**E4448A-06A**

**S E R V I C E N O T E**

**PSA Series Spectrum Analyzer**

**E4440A, E4443A, E4445A, E4446A and E4448A**

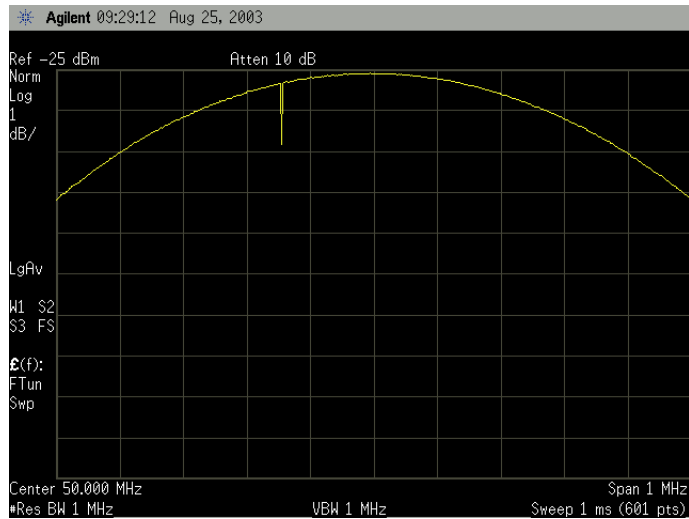
A hardware defect has been detected in the above range of PSA series spectrum analyzers. This defect can cause measurements to be made not to the specified performance of the instrument. The effected assembly is the A7 Digital IF assembly. Customer notifications will begin in early October, 2003. Please perform the following procedure to determine if the instrument does require modification.

Effected instruments will randomly show an amplitude drop of approximately 2 to 3 dB.

Replace the A7 Digital IF assembly P/N E4440-60025 or E4440-60195 with the Digital IF exchange assembly P/N E4440-69195. Perform recommended performance verification procedures and possible adjustments. Please reference the PSA Service guide for additional details.
